Project:  
**16 Middle Street**

Door and Window Schedule

**A8.01**

**3 | 1ST FLOOR - DOORS**  
1/32" = 1'-0"

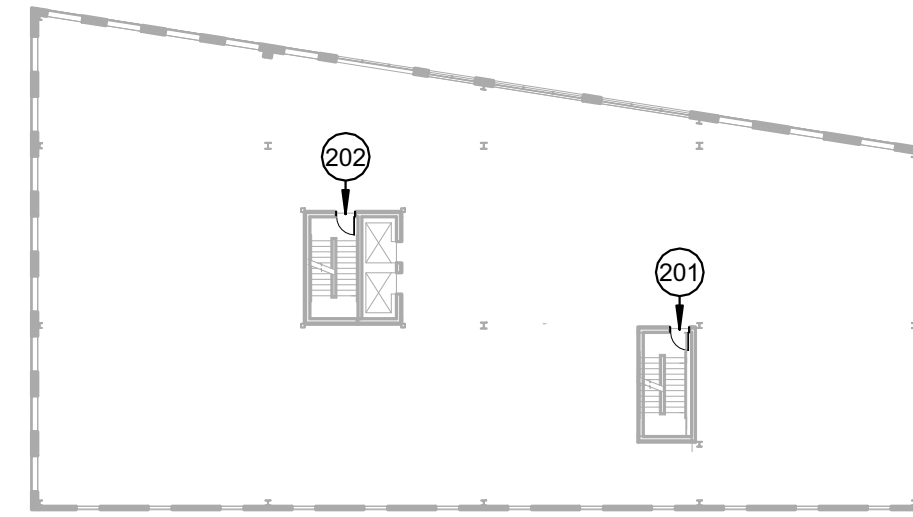
Please address the rating of these 2 doors that are in the 2 hour rated exterior wall

Doors not required to be rated per Table 705.8 where wall is permitted to have at least 25% of exterior all areas containing unprotected openings.
